Product Alert Notification (PAN)

Subject: Product Marking Change

Publication Date: 1/29/2024

DA16600MOD-AAC

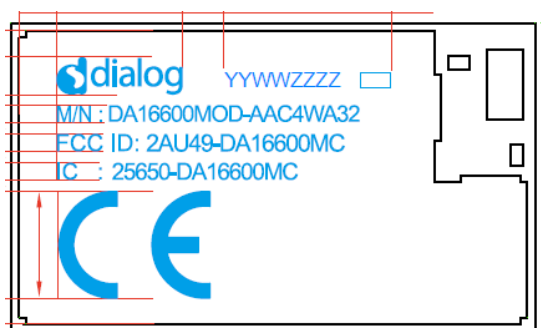
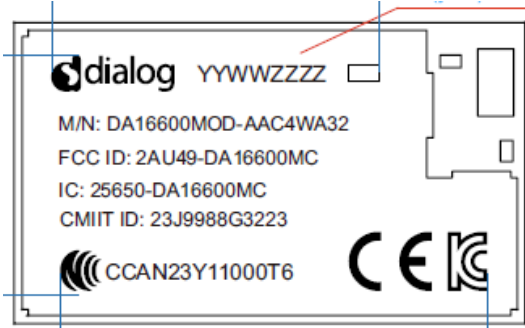
Renesas is changing the log on the shield-can because of NCC and SRRC certification.
